# UNITED STATES PATENT AND TRADEMARK OFFICE

APPLICATION NO.	FILING DATE	FIRST NAMED INVENTOR	ATTORNEY DOCKET NO.	CONFIRMATION NO.
10/618,272	07/11/2003	Chun He	2107-26	4842

## Office Action Summary

## **DETAILED ACTION**

Fig.3

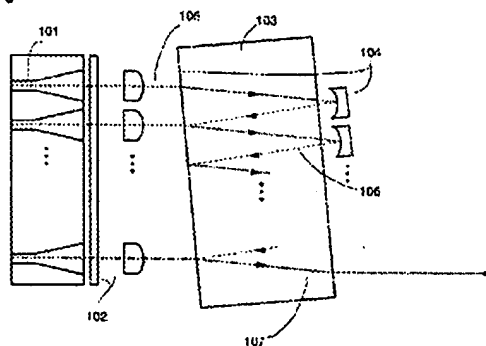
Neuberger discloses, as in claims 1 and 13, a module comprising: at least a concave mirror (104) placed in such way that an incident traveling distance of a light beam to the concave mirror is equal or substantially similar to a reflective traveling distance of the light beam from the concave mirror (see figure 3 below). Though Neuberger does not explicitly disclose the tilting error correction, this feature is considered an inherent function of the device employing the concave reflector in the multiplexing device disclosed.

multiplexing device disclosed, and the angular error and a later shift error of claim 8, absent additional structure, is likewise considered inherent to Neuberger (see fig. 3, col. 5, lines 50-52).
